J2023-0143
PSP2024-0013
Revision m#3
Received 2/7/2025

City of Rochester
Hills Planning &
Economic
Development

Site Plan Review

SITE PLANS for: PROPOSED GAS STATION

UTILITY PLAN

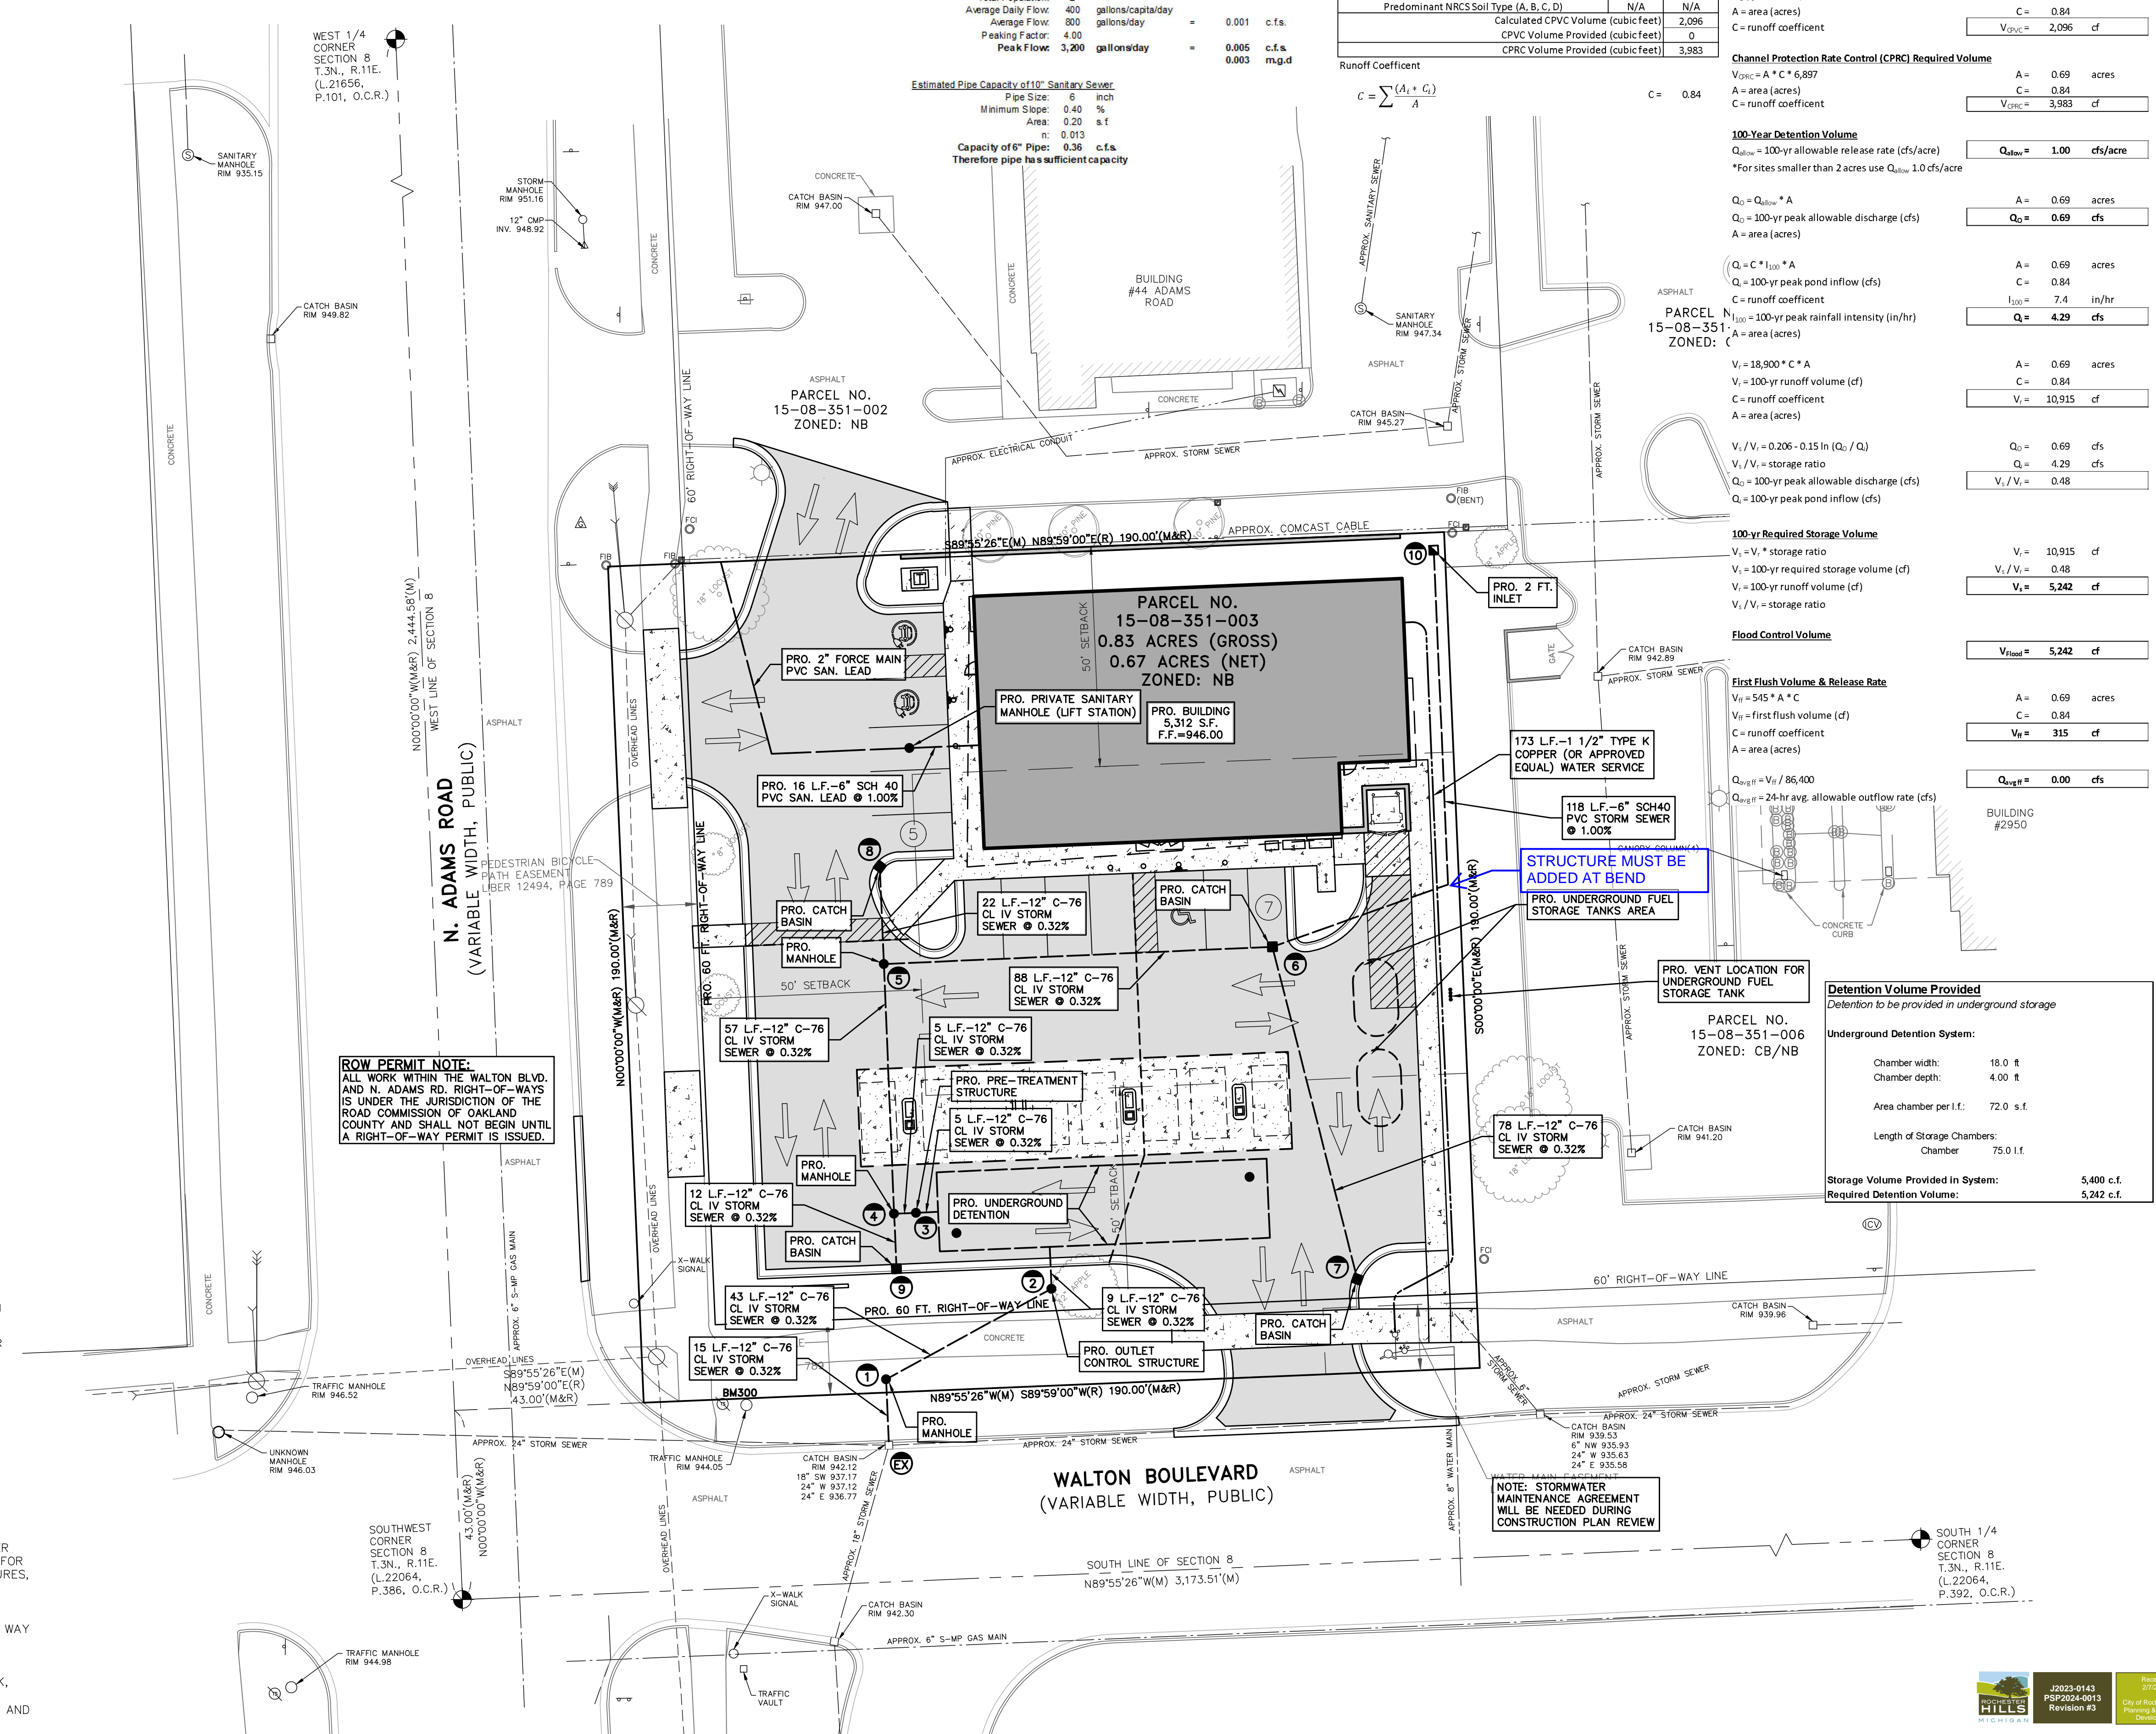
STRUCTURE MUST BE ADDED AT BEND

Landscape Plan

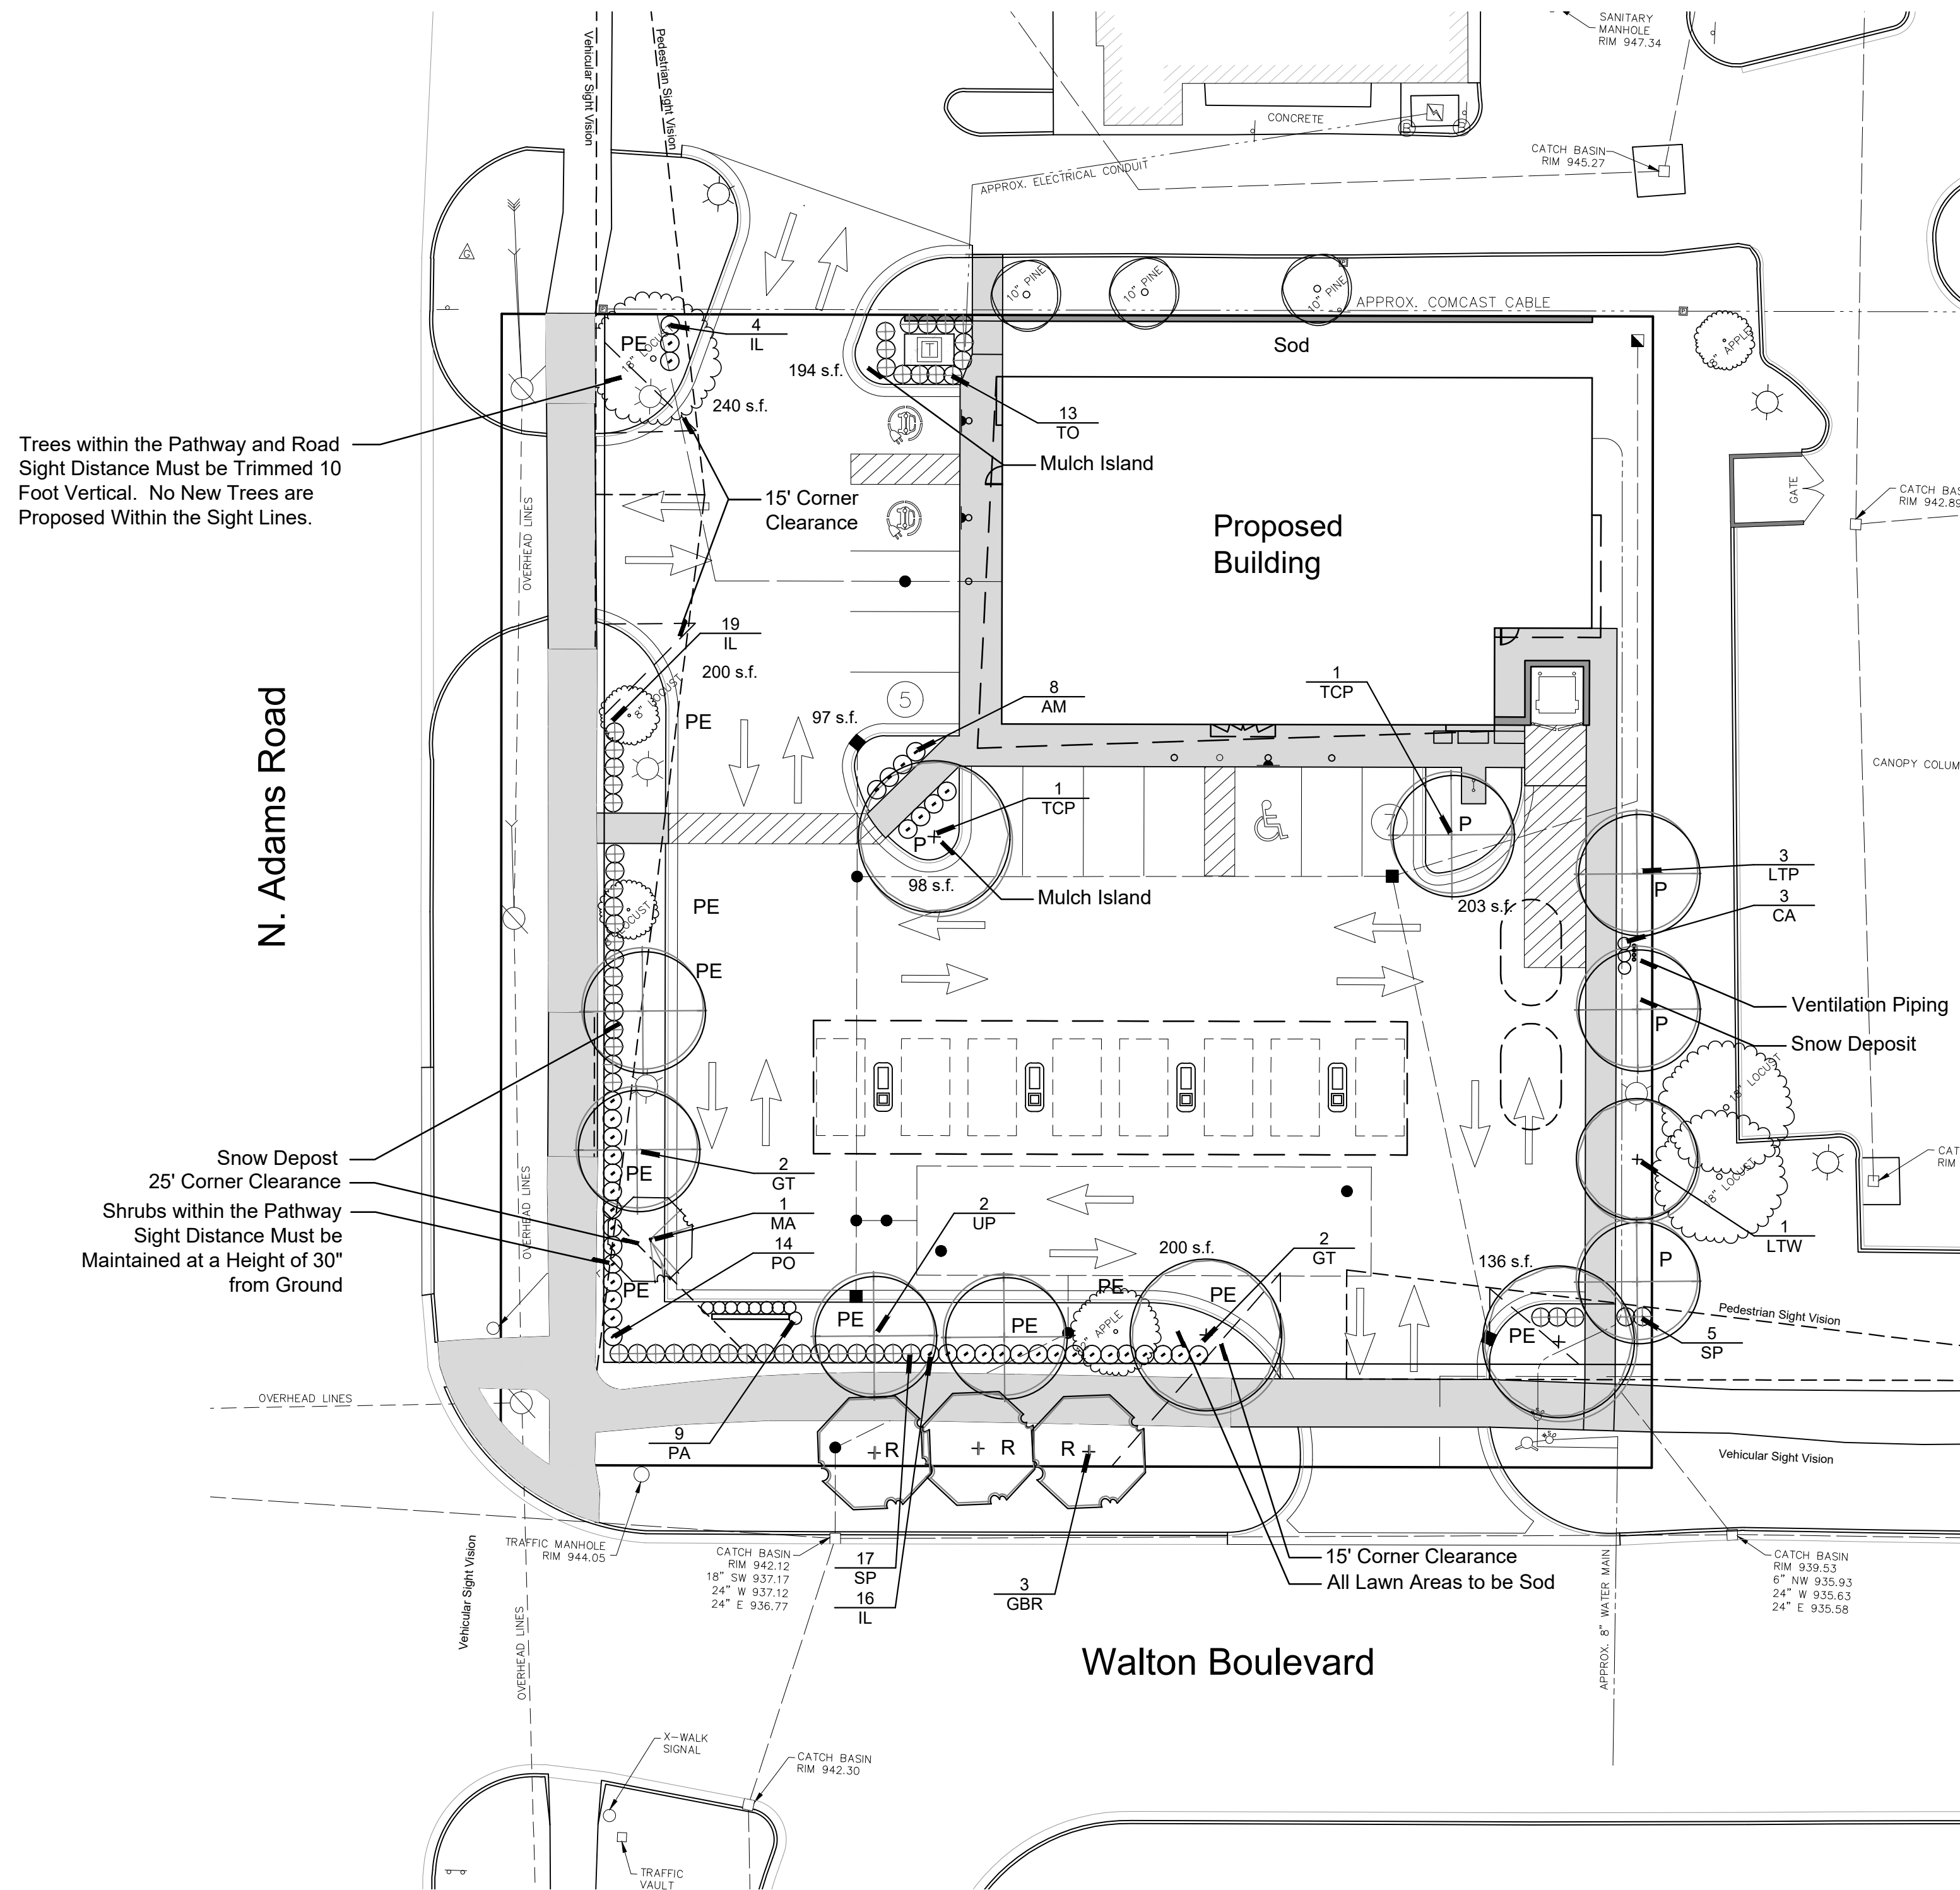
Additional monies into Tree Fund if trees shown on landscape plan are not permissible to plant.
